**SAN FRANCISCO UNIFIED SCHOOL DISTRICT
2011 PROPOSITION A BOND PROGRAM
GORDON J LAU ELEMENTARY SCHOOL
WINDOW & ROOF REPLACEMENT**

ADDENDUM NO. 2

PROJECT: Window & Roof Replacement
Gordon J Lau Elementary School
950 Clay Street, S.F., CA 94108

DATE: March 17, 2016

DWG SHEET REF: A2.21
ISSUE REF: ADDENDUM 2
SKETCH #: AD2-A2.21A
 ISSUE DATE: 03/16/16

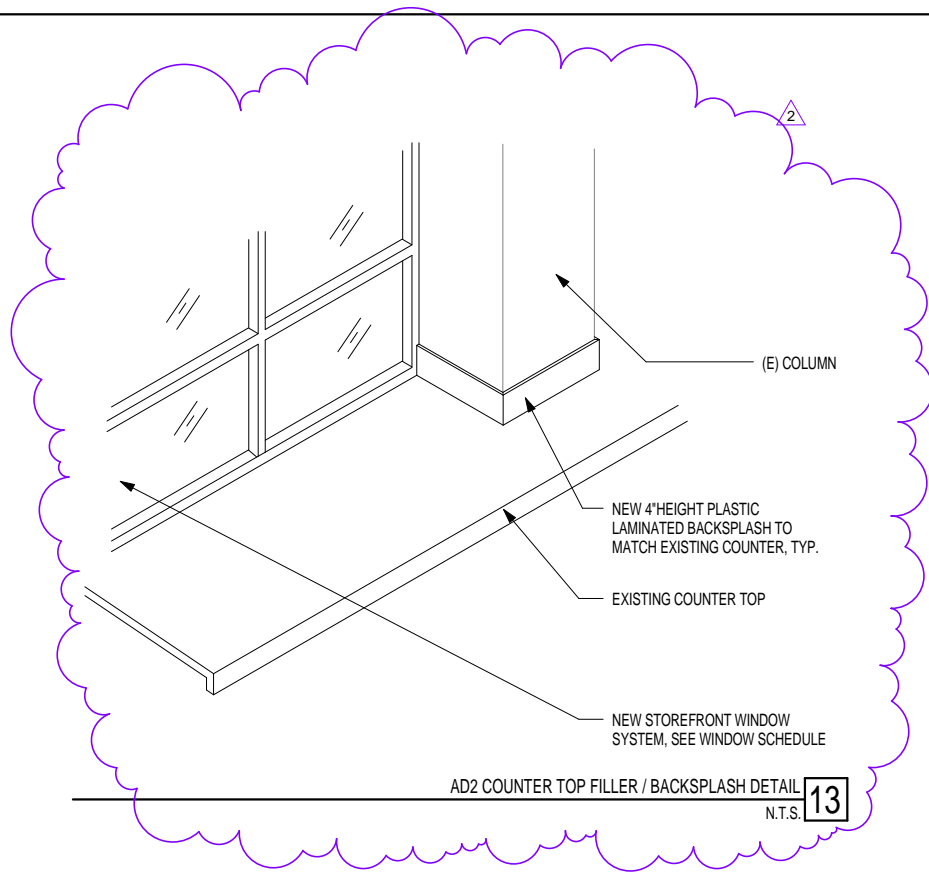
AD02A.05 Attachments: AD2-A2.21A

Reference: A2.21

Description: See attached **AD2-A2.21A** for added details to **A2.21**.

DSA APP#: N/A
 DRAFTED BY: Author
 DWG SHEET REF: A8.02
ISSUE REF: ADDENDUM 2
SKETCH #: AD2-A8.02A
 ISSUE DATE: 03/16/16

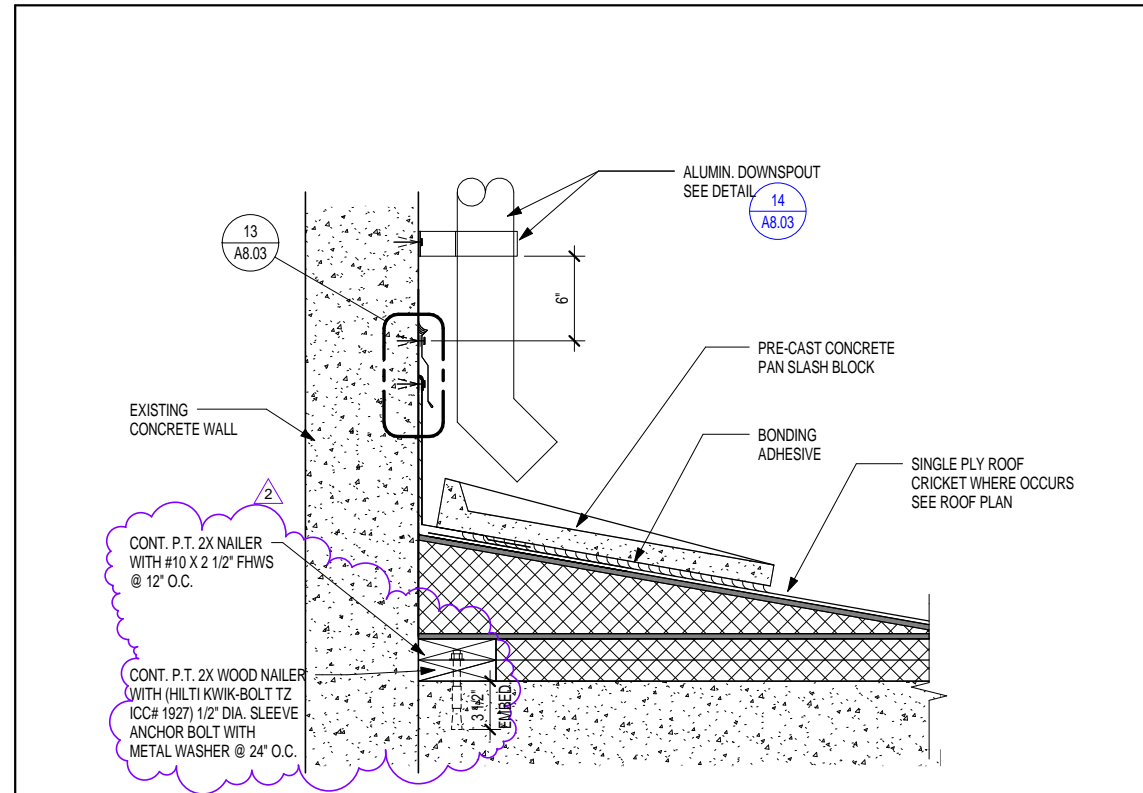
AD02A.06 Attachments: AD2-A8.02A

Reference: A8.02

Description: See attached **AD2-A8.02A** for added detail to **A8.02**.

DSA APP#: N/A
 DRAFTED BY: Author
 DWG SHEET REF: A8.04
ISSUE REF: ADDENDUM 2
SKETCH #: AD2-A8.04A
 ISSUE DATE: 03/16/16

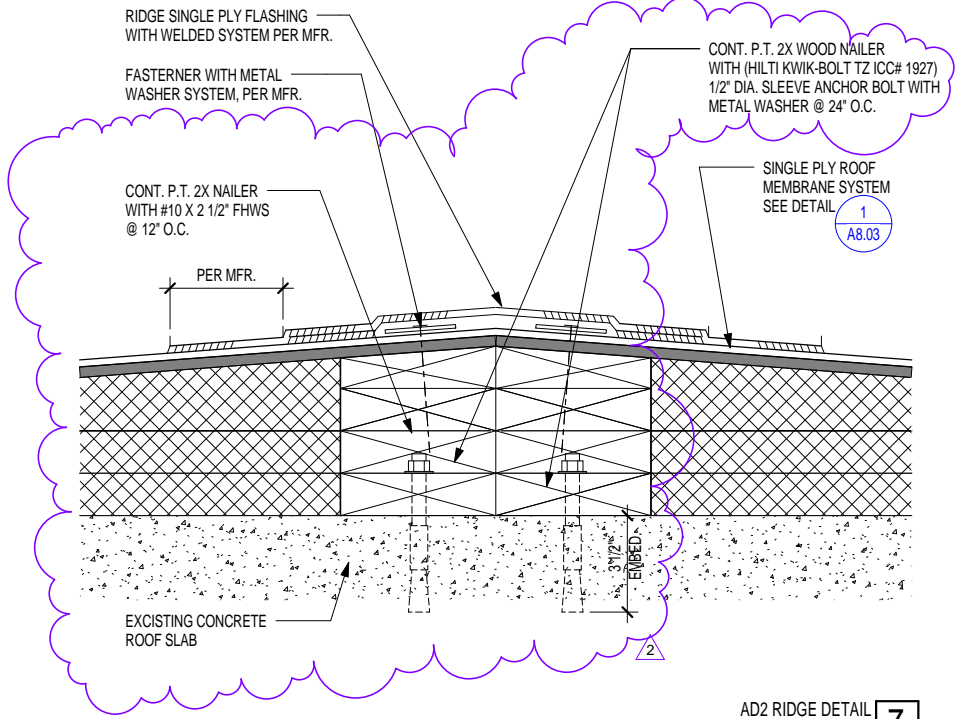
AD02A.06 Attachments: AD2-A8.04A

Reference: A8.04

Description: See attached **AD2-A8.04A** for revised details to **A8.04**.
